Supplemental Note:
Dewatering Assessment in Station Boxes and SCL Tunnels

MetroLink

Project No: 32108600
Document Title: Supplemental Note: Dewatering Assessment in Station Boxes and SCL Tunnels
Document No.: TBC
Revision: P01
Date: 04/03/2024
Client Name: TII / NTA
Client No:
Project Manager: Paul Brown
Author: Jose A Aparicio
File Name: TBC

This technical note is structured such that each of the sub-sections 1.1 to 1.6 included below addresses the particular query posed by the Inspector's Experts during Module 1 of the Oral Hearing currently in progress (initial queries raised on the 22nd of February, day 4, and additional queries raised on the 29th of February, day 8 of the OH).

1.- STATION BOX INFLOW RATES WITHOUT D-WALLS TOE FISSURE GROUTING INTO THE ROCK MASS.

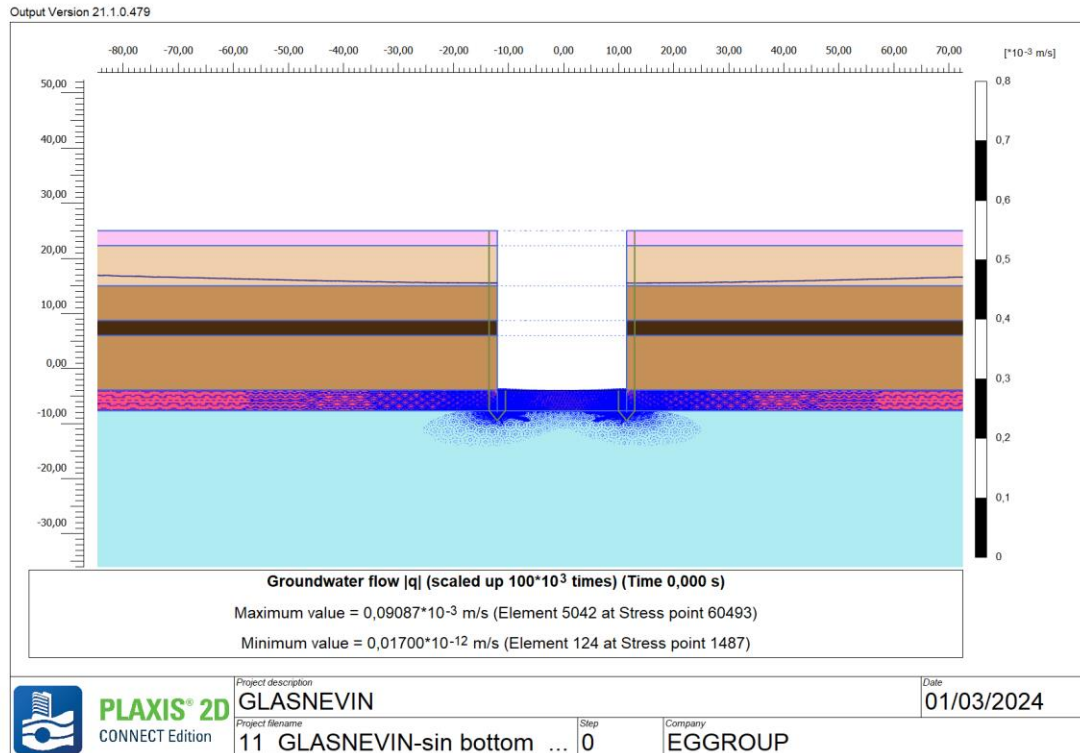
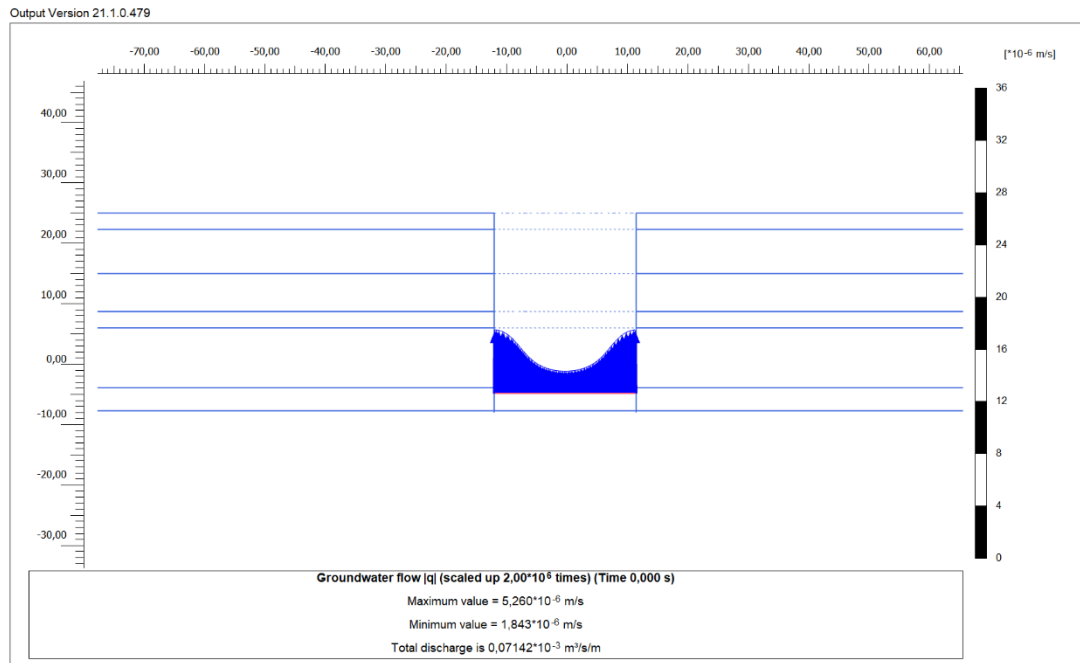
1.1 Can TII detail the dewatering strategy and the related settlement issues?

Flow rates = $0,071 \times 10^{-3} \text{ m}^3/\text{s}/\text{m}$ ($6.13 \text{ m}^3/\text{d}/\text{m}$ or 6.81 l/s along the whole station)

Water inflow through the bottom of Glasnevin station box without D-walls toe grouting

Flow rates to the bottom of Glasnevin station box

Lowering of the groundwater level. Decrease of approximately four (4) meters.

3.- STATION BOX INFLOW RATES CONSIDERING D-WALLS TOE FISSURE GROUTING 5M INTO THE ROCK MASS AND FISSURE GROUTING AT THE BOTTOM OF THE STATION BOX.

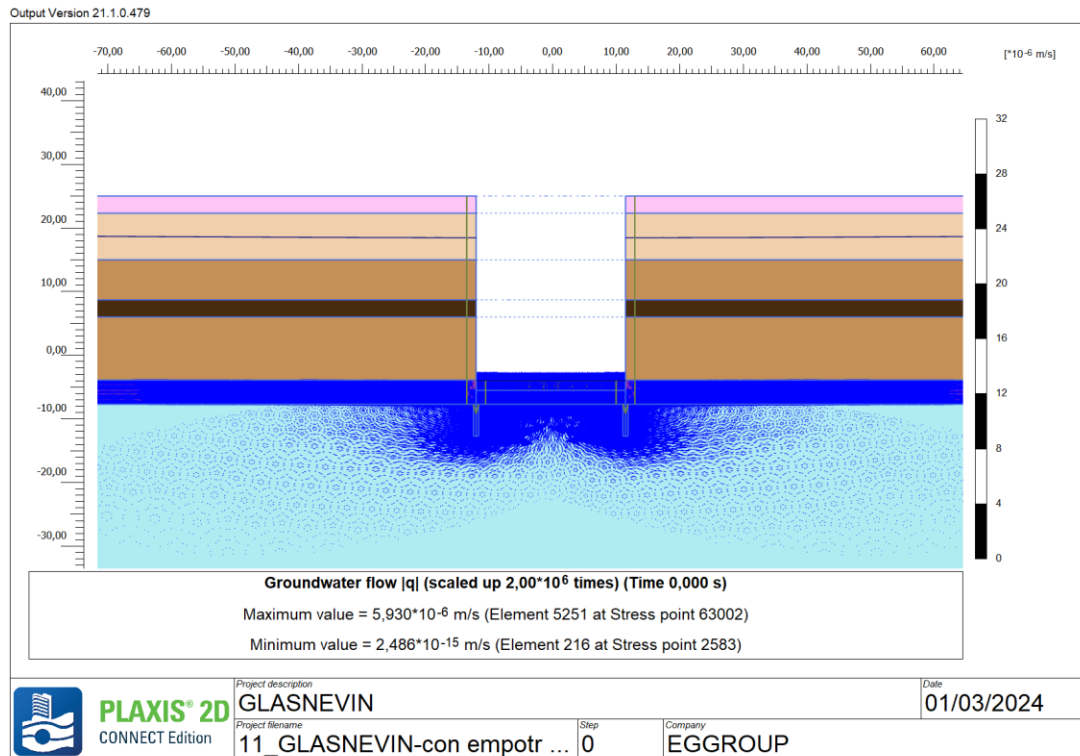
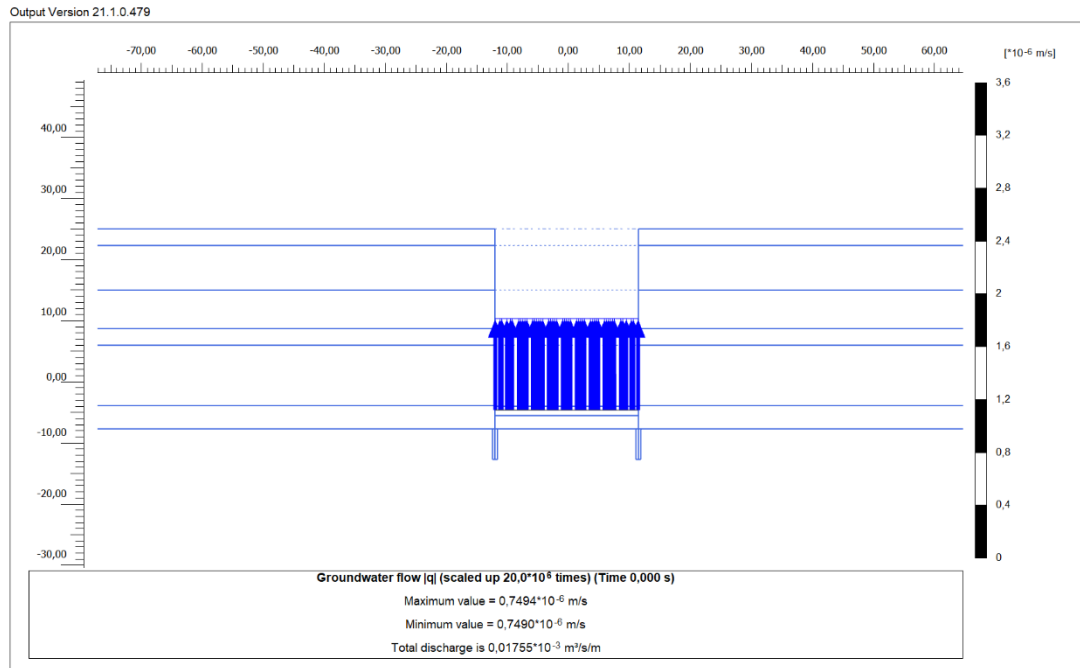
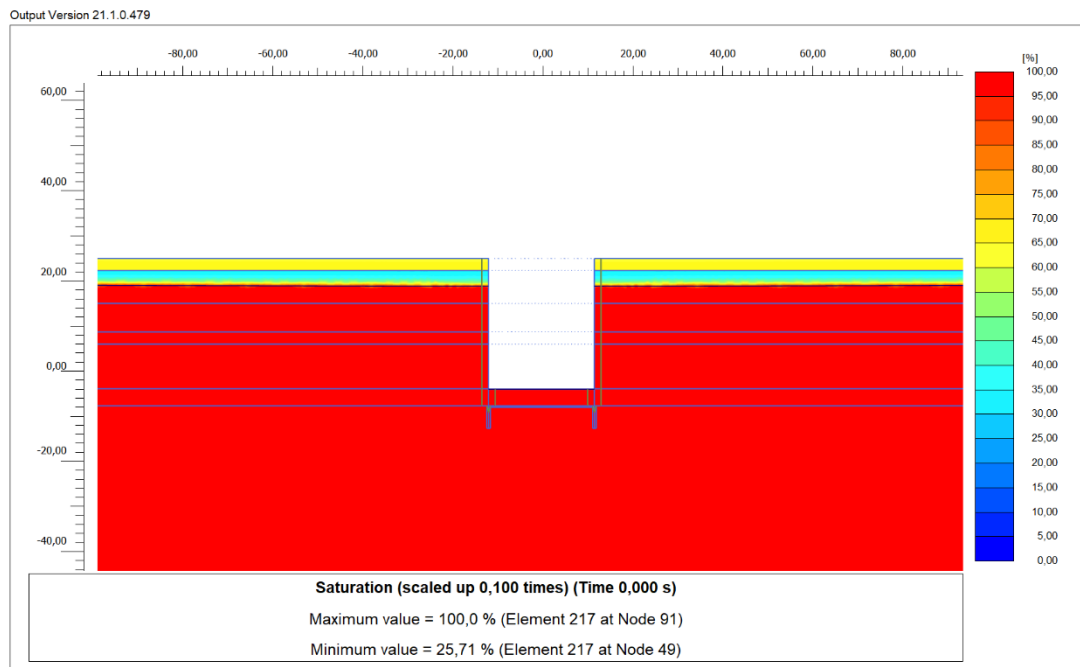
1.3 How will the 0.5l/ sec of dewatering be achieved at the station boxes?

Flow rates = $0,018 \times 10^{-3} \text{ m}^3/\text{s}/\text{m}$ ($1.5 \text{ m}^3/\text{d}/\text{m}$ or 1.7 l/s along the whole station)

Groundwater level remains unchanged.

Flow rates to the bottom of Glasnevin station box

Groundwater level remains unchanged.

1.- EXCAVATION WITHOUT GROUTING AT THE TUNNEL FACE

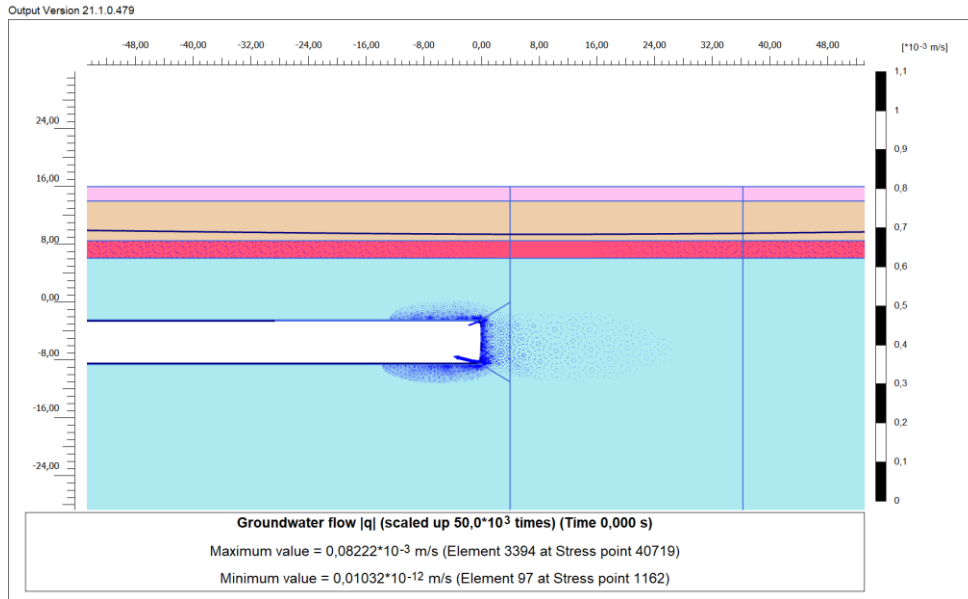
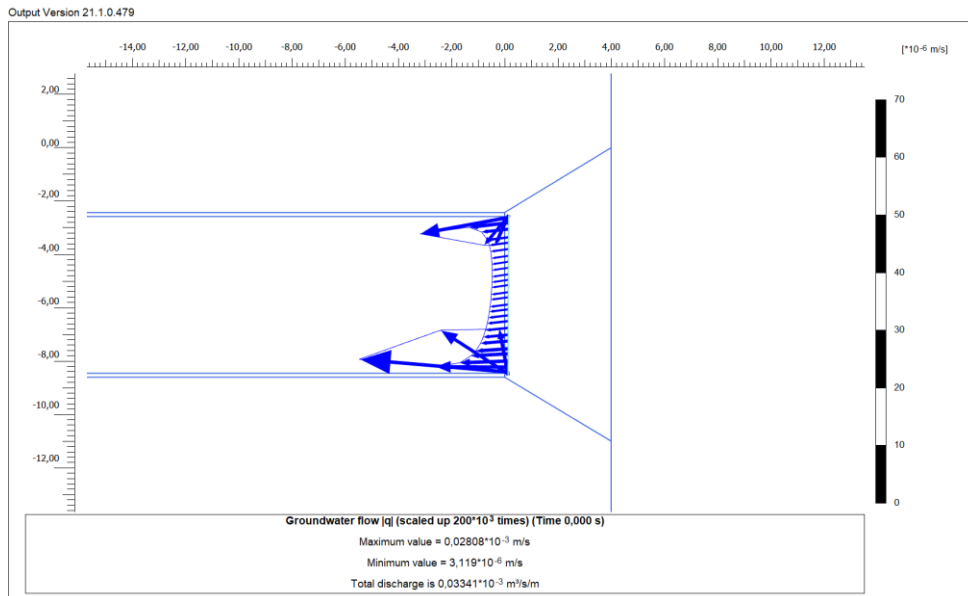
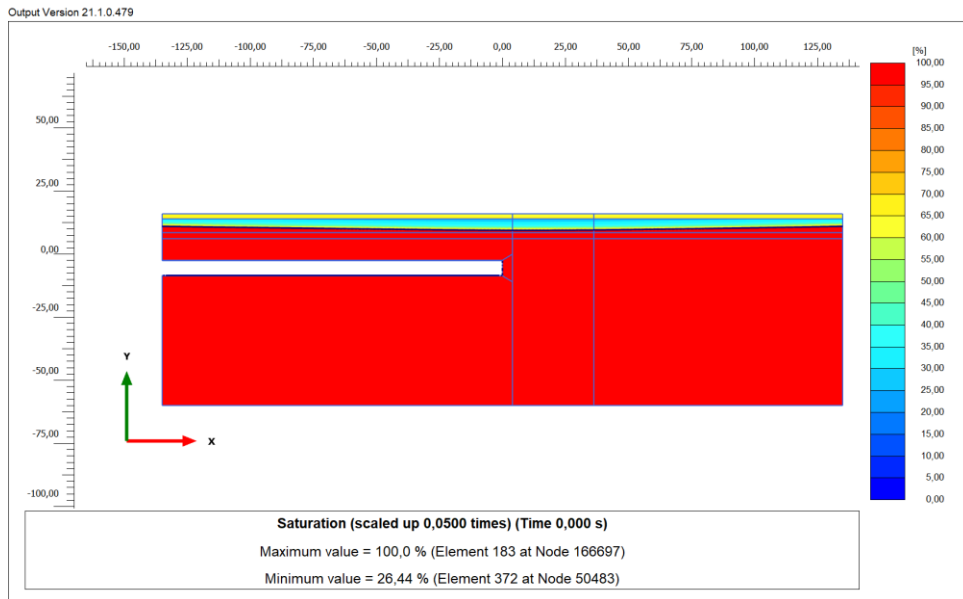
1.4 What is your strategy for dewatering control before the permanent membrane is installed in the construction of the Charlemont Intervention Tunnel?

Flow network towards the tunnel face excavation

Flow rates of 33 l/s/m (\approx Section $A=33\text{m}^2$). $Q_{\text{total}} = 33 \times 5.5 = 181\text{l/s}$

In this case Lowering of the groundwater level. Decrease of 1.6m.
